MANDATORY SERVICE BULLETIN

NO. MSB-40-054/1

NO. MSB-F4-013

“Protection of Pitot, Static and Stall Warning Lines”

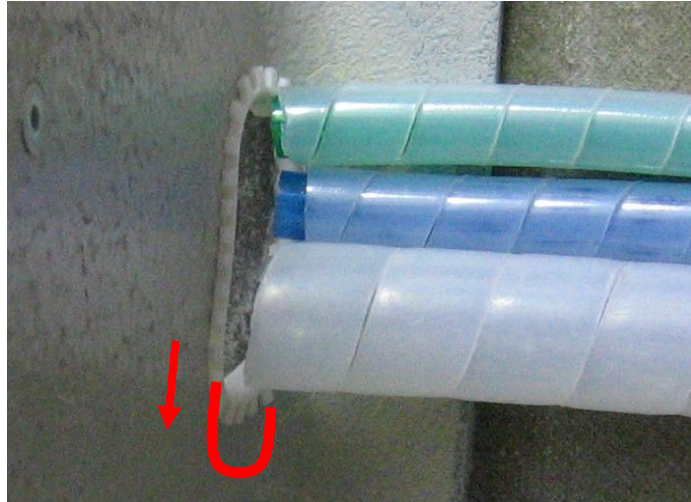
2	Remove pilot seat according to AMM, chapter 25.
3	<p data-bbox="276 436 1401 537">Inspect the pitot, static and stall warning lines at the through hole in the aft floor panel wall. If the diameters of any of the lines have been reduced by more than 30%, the lines must be replaced.</p> 
4	<p data-bbox="276 1214 1401 1314">Ensure that any tie wrap bases are secured to the fuselage wall behind the side pocket. If a tie wrap base has been dislodged from the fuselage wall, bond it back into its original position using commercial 5 min Epoxy adhesive.</p>

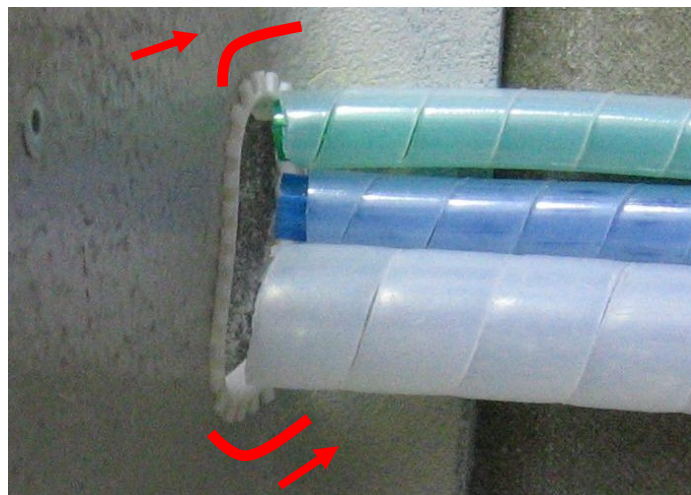
Wrap the pitot and static lines with spiral-wrap, P/N T38F and the stall warning line with spiral-wrap, P/N T62F. Wrap spiral-wrap around each line individually down their full length until the point where they pass behind the instrument panel. The spiral-wrap should also extend aft beyond the floor panel wall a minimum of 50mm.

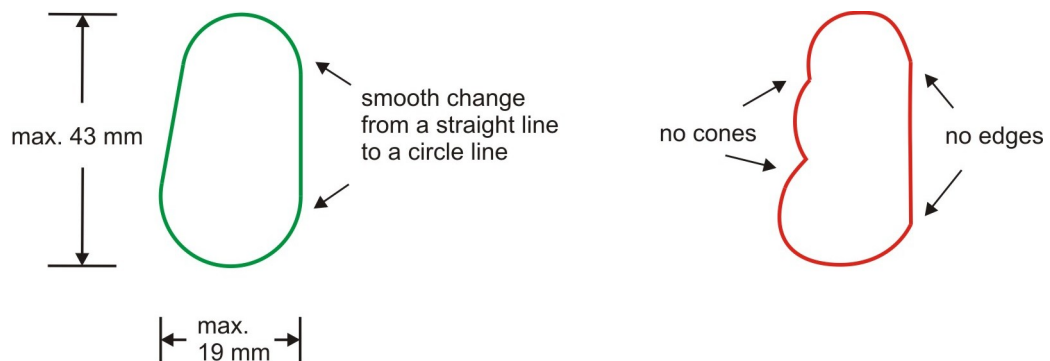
Check to see that the through-hole in the aft wall of the floor panel is large enough to route the 3 lines (wrapped in spiral wrap) side by side without excessive bunching. If it is not, remove the edge guard from the inside edge of the hole and elongate the hole vertically down only as required to allow the lines to sit side by side.

NOTE: Do not enlarge the hole vertically to more than 43 mm (the thickness of the edge protection already taken into account).

- 9 Elongate the hole horizontally outboard so that the outboard edge of the hole is flush with the outboard face of the floor panel.

NOTE: If after making the outboard edge of the hole flush with the outboard face of the floor panel the lines including the spiral wrap do not fit through the hole, enlarge the hole horizontally inboard up to a maximum of 19 mm (the thickness of the edge protection already taken into account).

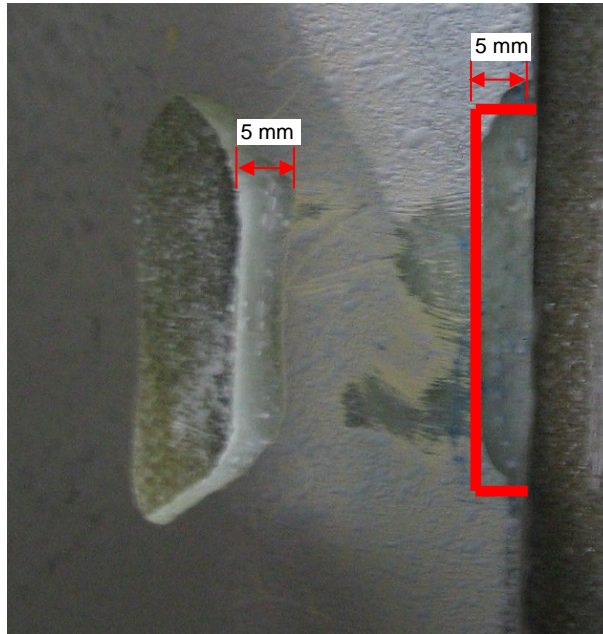
If you find an installation as it is shown on the photograph below, then elongate the three holes so that they become a long one as it is described in step 9.

NOTE: When finding an installation with three single holes through the aft wall of the floor panel the given maximum length of 43 mm may be increased up to a maximum length of 60 mm.

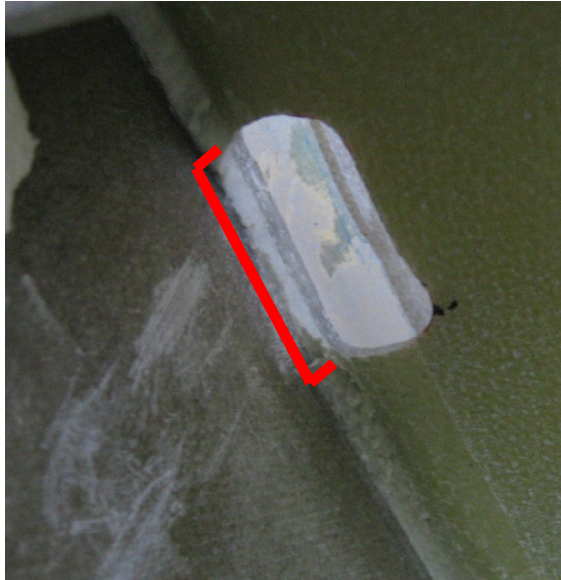
It is important that the hole does not have an unsteady shape but a smooth one. An example how it should look like and how it should not look like are shown below.

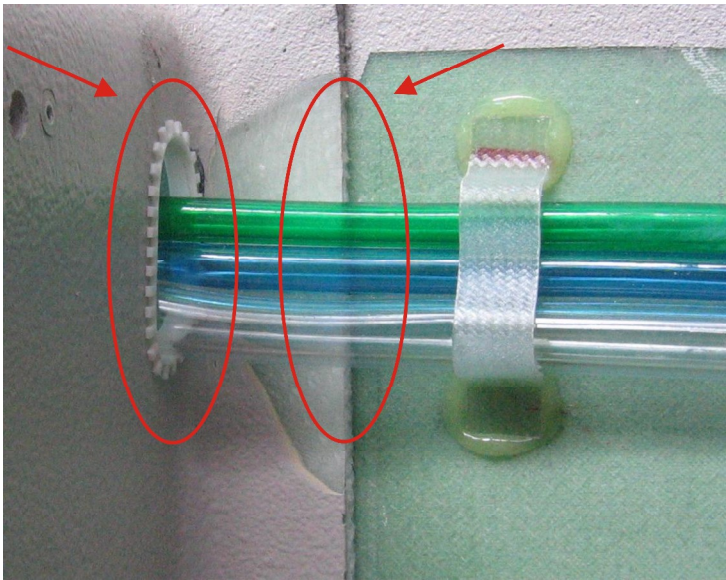
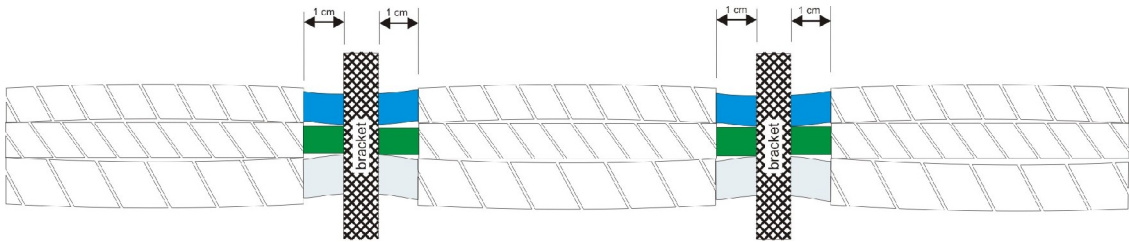
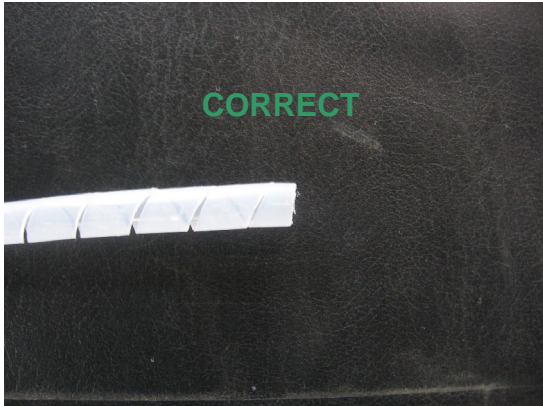
Chamfer the forward edge of the floor panel bonding flange behind where the lines are routed. The chamfer (approx. 45°) should not remove any more than 5 mm of the bonding flange material.

CAUTION: Do not damage the surrounding composite material.

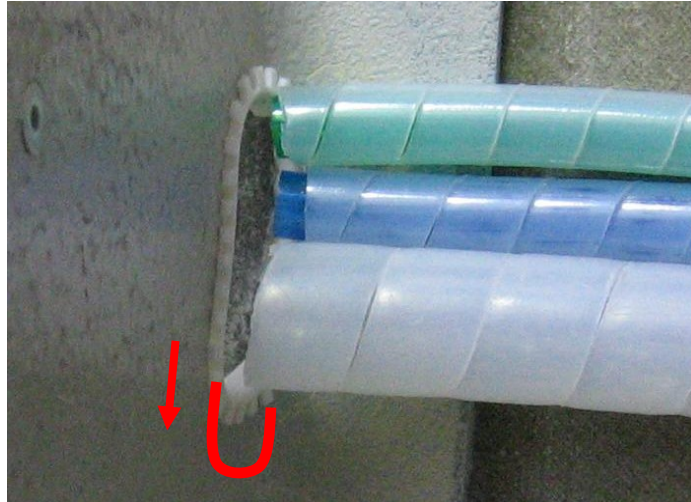
13	<p>Chamfer the aft side of the outboard edge of the through hole in the floor panel. The chamfer (approx. 45°) should not remove any more than 5 mm of the bonding flange material.</p>  <p>CAUTION: Do not damage the surrounding composite material.</p>
14	<p>Install edge protection, P/N GE128-C69 on the inboard, top & bottom edges of the hole using a small amount of commercial 5 min Epoxy adhesive.</p>

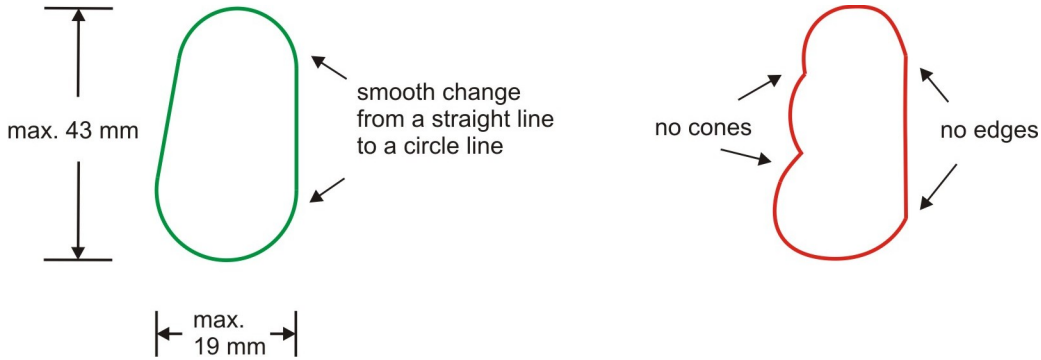
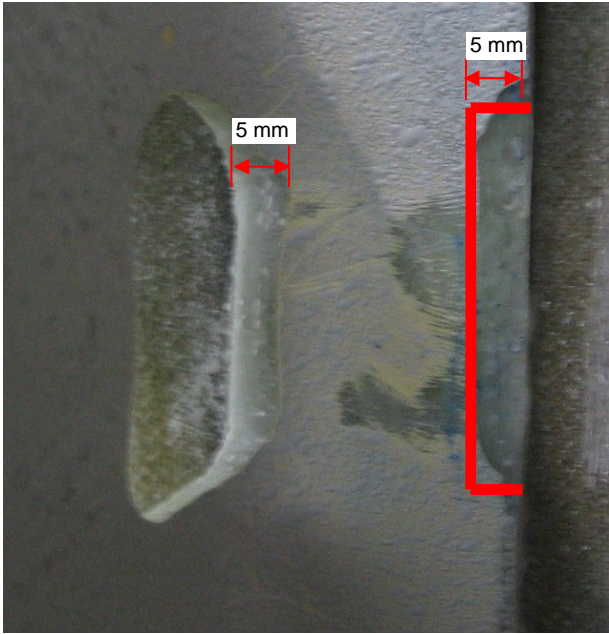
Check to see that the through-hole in the aft wall of the floor panel is large enough to route the 3 lines (wrapped in spiral wrap) side by side without excessive bunching. If it is not, remove the edge guard from the inside edge of the hole and elongate the hole vertically down only as required to allow the lines to sit side by side.

NOTE: Do not enlarge the hole vertically to more than 43 mm (the thickness of the edge protection already taken into account).

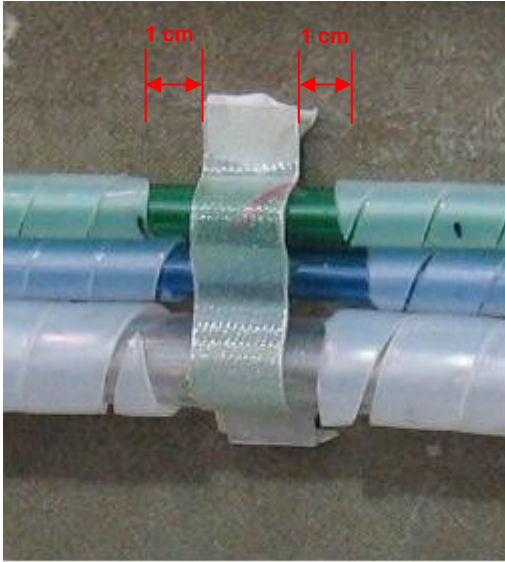
- 7 Elongate the hole horizontally outboard so that the outboard edge of the hole is flush with the outboard face of the floor panel.

NOTE: If after making the outboard edge of the hole flush with the outboard face of the floor panel the stall lines including the spiral wrap do not fit through the hole, enlarge the hole horizontally inboard up to a maximum of 19 mm (the thickness of the edge protection already taken into account).

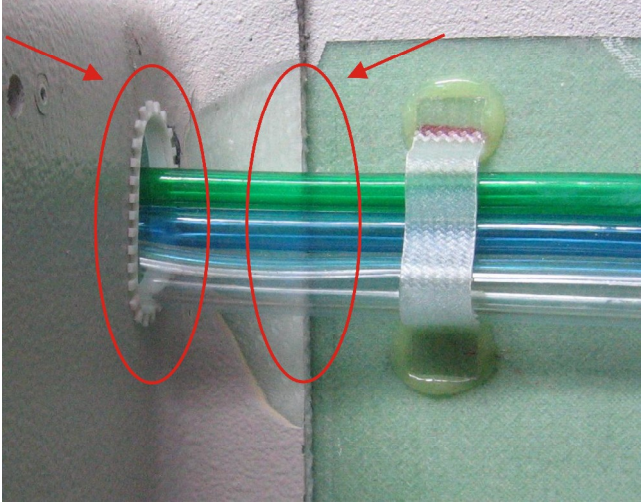
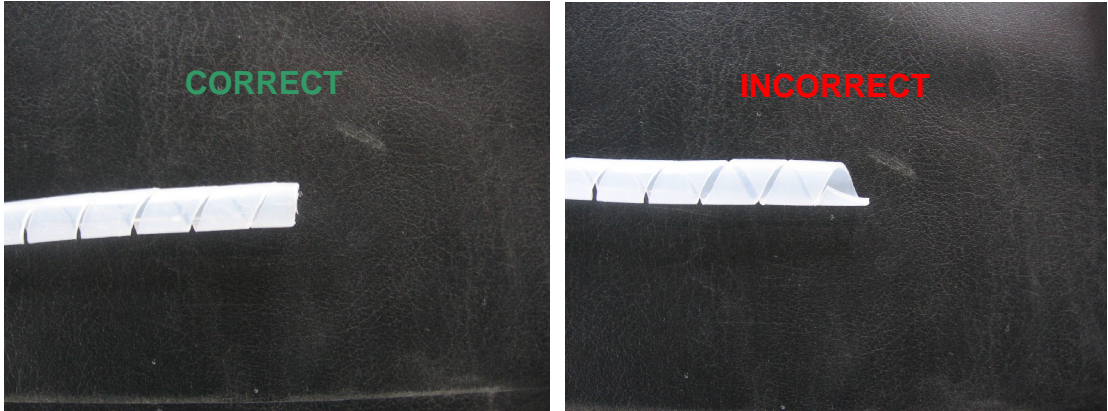
8	<p>It is important that the hole does not have an unsteady shape but a smooth one. An example how it should look like and how it should not look like are shown below.</p> 
9	<p>Chamfer the forward edge of the floor panel bonding flange behind where the lines are routed. The chamfer (approx. 45°) should not remove any more than 5 mm of the bonding flange material.</p>  <p>CAUTION: Do not damage the surrounding composite material.</p>

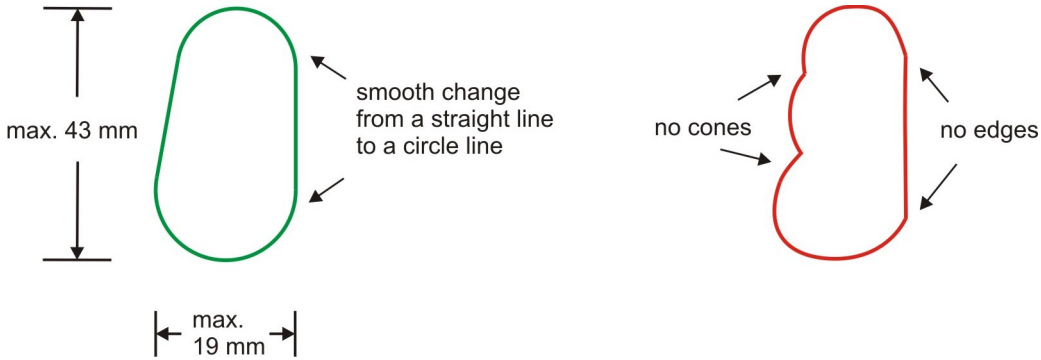
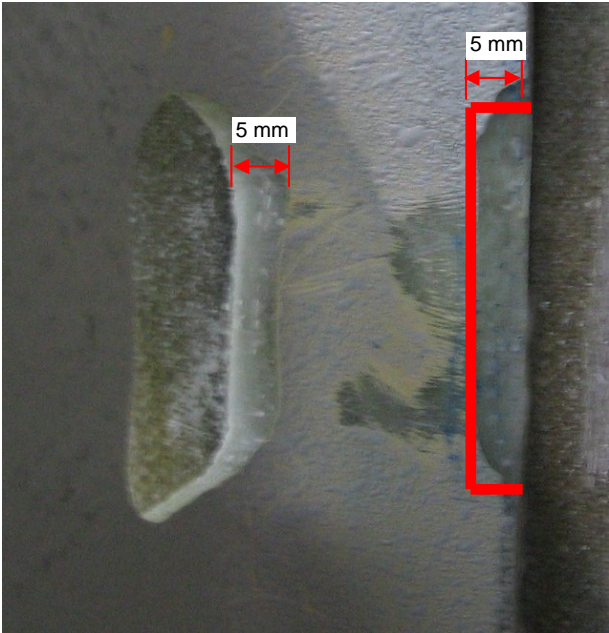
Check to see that the through-hole in the aft wall of the floor panel is large enough to route the 3 lines (wrapped in spiral wrap) side by side without excessive bunching. If it is not, remove the edge guard from the inside edge of the hole and elongate the hole vertically down only as required to allow the lines to sit side by side.

NOTE: Do not enlarge the hole vertically to more than 43 mm (the thickness of the edge protection already taken into account).

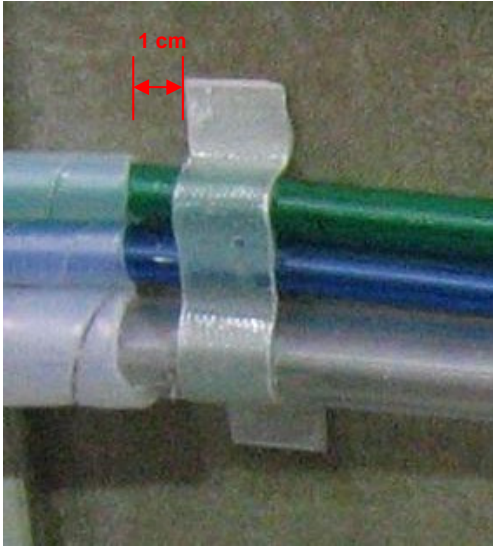
- 7 Elongate the hole horizontally outboard so that the outboard edge of the hole is flush with the outboard face of the floor panel.

NOTE: If after making the outboard edge of the hole flush with the outboard face of the floor panel the stall lines including the spiral wrap do not fit through the hole, enlarge the hole horizontally inboard up to a maximum of 19 mm (the thickness of the edge protection already taken into account).
